The Dow Chemical Company
Midland, Michigan 48667

Subject: The Dow Chemical Company- License No. R-108; Docket No. 50-264

Attachment I

DTRR response to RAI letter dated March 6, 2014: Questions 1 through 24.

Figure 6.1. Administration

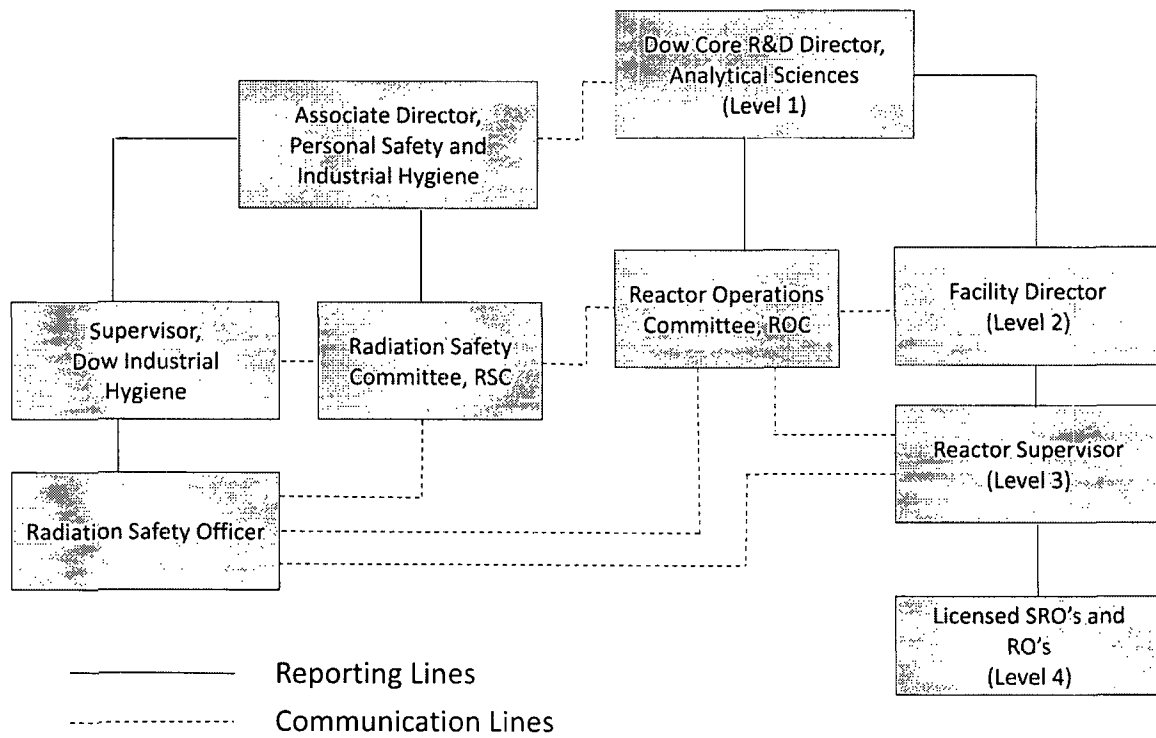
RAI-12. The proposed DTRR TS 6.1.1, "Structure," Figure 6.1., indicates a communication relationship (i.e., the dashed line) between the Dow Core R&D Director (Level 1) and the Reactor Operations Committee (ROC). However, NUREG-1537 provides guidance that the review/audit group should report (i.e., a solid line) to the Level 1. Additionally, the Radiation Safety Committee (RSC) appears to have a typographical error as "ROC" is referenced in the RSC box. Provide justification for the communication relationship in proposed TS Figure 6.1, or revise to indicate a reporting relationship consistent with the guidance in NUREG-1537.

RAI-17. The proposed DTRR TS 6.2.2, "ROC Rules," Item e, states, in part, that "[t]he ROC shall report at least twice per year to the Radiation Safety Committee (RSC) through presentations by the reactor supervisor at the quarterly RSC meetings." However, it is not clear how the "report" through presentations is accomplished. Provide justification for the proposed TS 6.2.2, Item e, or revise to provide clear guidance as to how the ROC communicates the audit findings. Confirm that TS Figure 6.1 accurately depicts the relationship between the ROC and RSC.

TS 6.1.1, Figure 6.1, has been revised by including reporting lines between the ROC and the Level 1 manager in the DTRR TS (April 2014). Also, the typographical error has been corrected.

TS 6.2.2, item e, has been revised by removing the phrase "report" and replacing it with the phrase "communicate" in the DTRR TS (April 2014). TS 6.2.2, item e, is now consistent with Figure 6.1 in the DTRR TS (April 2014)
